Parks and Trails Advisory Board Agenda
Monday, October 2, 2023 6:00pm

FDP-87-2023 Final Development Plan - Parkland and Open Space Review

Review and recommendation regarding the suitability of parkland and open space proposed to be provided as part a 151 lot, age-restricted residential housing development on 63.5+/- acres for the subdivision known as The Courtyards at Haines Creek.

The applicant requests a review and recommendation to the Planning Commission regarding the suitability of parkland and open space proposed in a new subdivision located at the northwest corner of the Central College Road and Jug Street Rd NW intersection. The subdivision is known as “Courtyards at Haines Creek”.

CITY OF NEW ALBANY, FRANKLIN COUNTY, OHIO
FINAL DEVELOPMENT PLAN
FOR
THE COURTYARDS AT HAINES CREEK
OPEN SPACE & PEDESTRIAN CONNECTIVITY PLAN

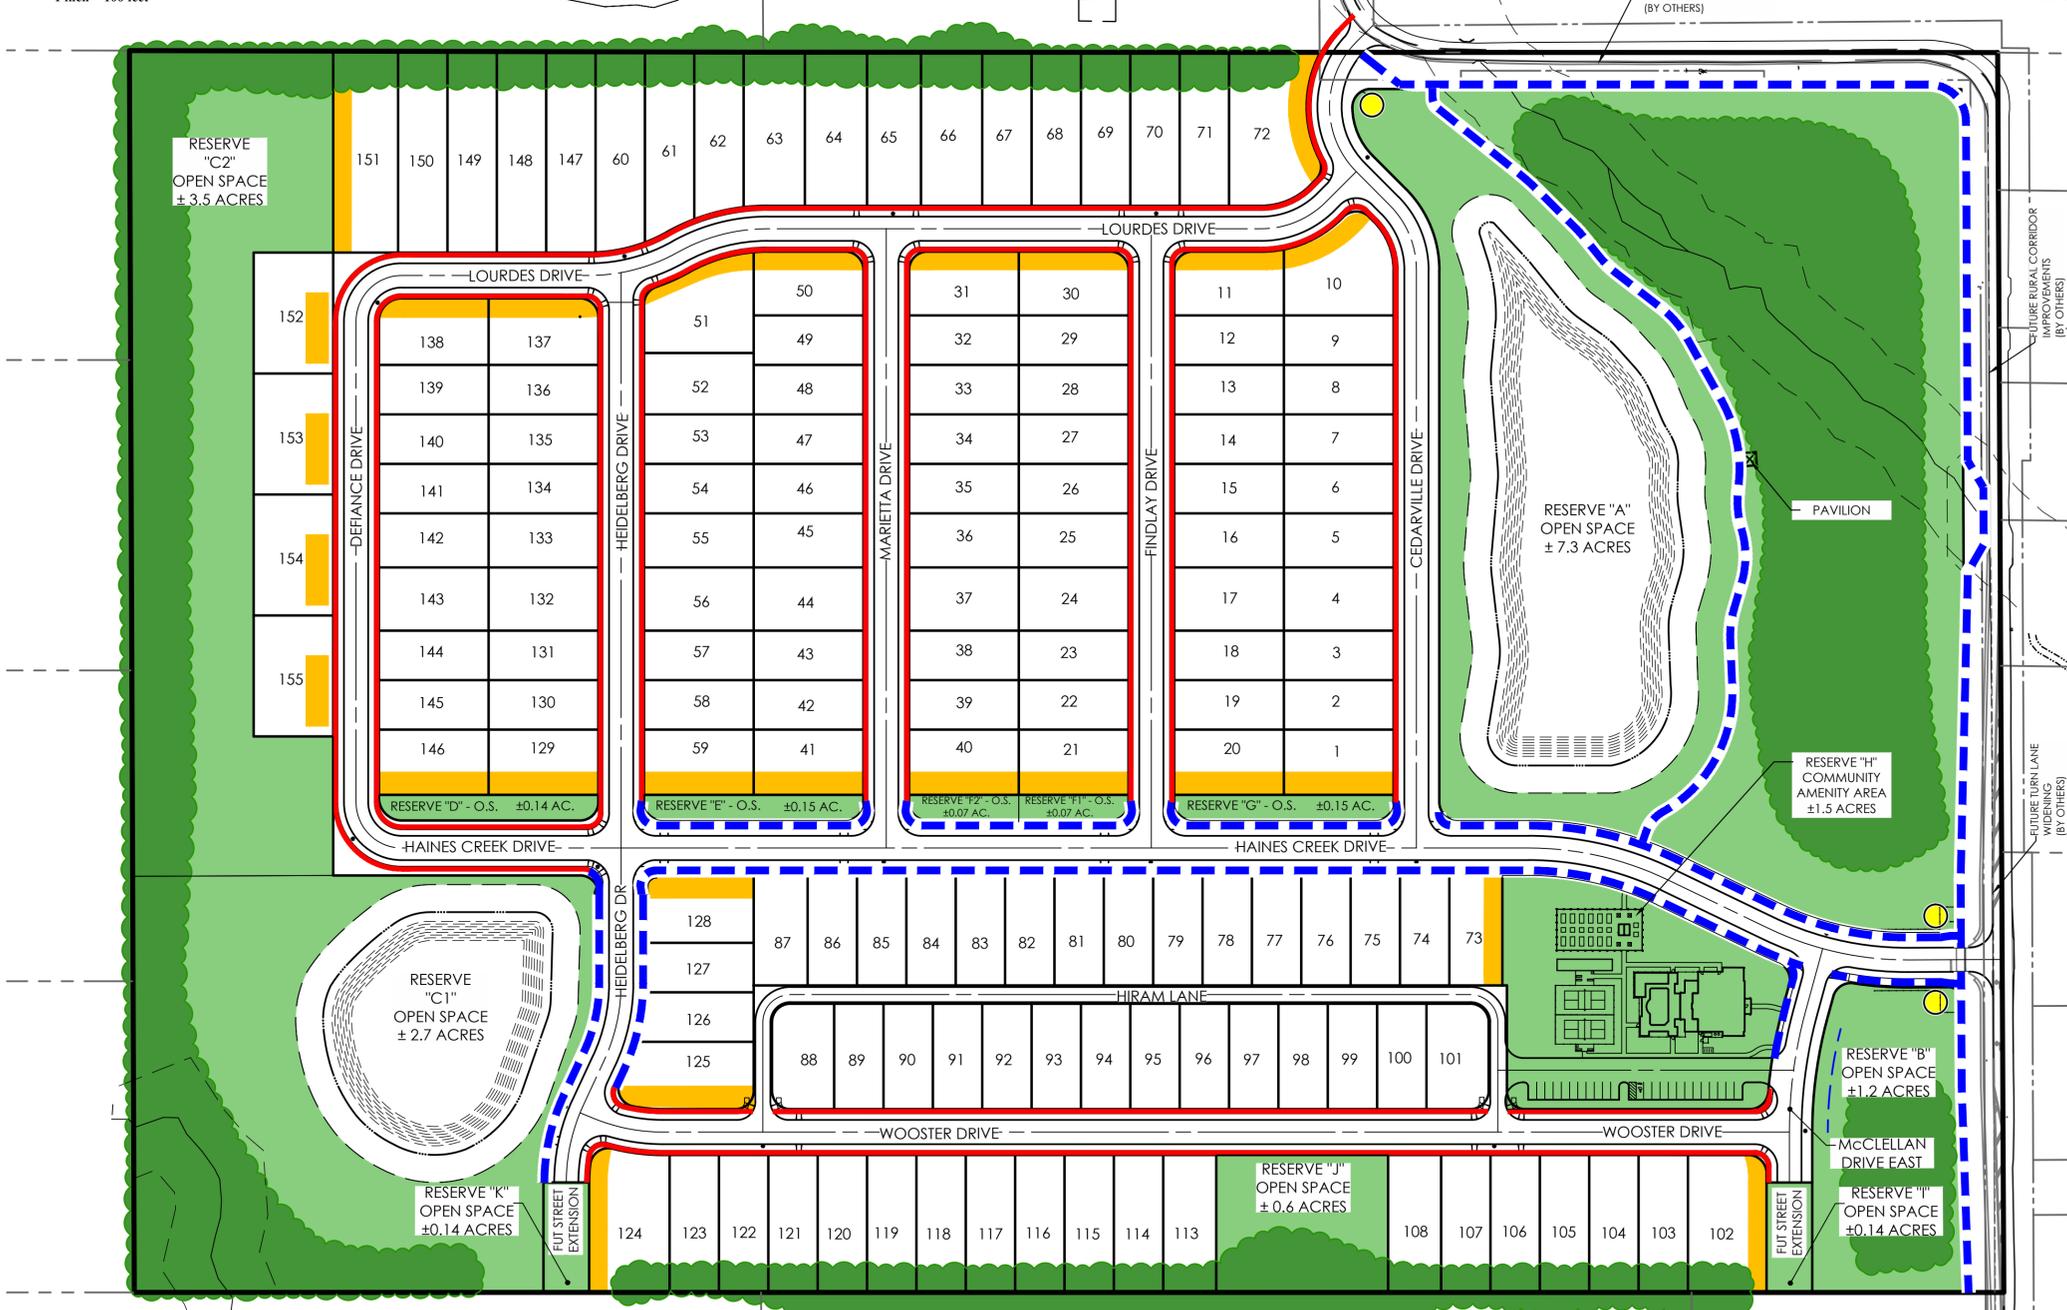
3. During the rezoning hearing, the city council directed the applicant to perhaps relocate up to four units shown on the preliminary development plan near the adjacent neighbor along the western boundary line to provide additional tree preservation. Those four homes have since been relocated to the northern area of the site and back onto Reserve C.

4. The text requires the applicant to install a 5-foot-wide public sidewalk within the right-of-way on each internal subdivision street (other than the North-South Street, the south side of Street 2, and the north side of Street 8), in the general locations shown in the final development plan. The total amount of sidewalk within the development is approximately 2 miles.

8. The zoning text states ownership and maintenance of the parkland and open space areas shown on the final development plan shall be defined and approved with the final development plan. The private community clubhouse shall be located as generally shown on the final development plan.

1. The open space amenities shall be installed and included as part of the overall subdivision infrastructure improvements (e.g. streets, utilities, etc.).
2. The final alignment of the leisure path shall be subject to staff approval.
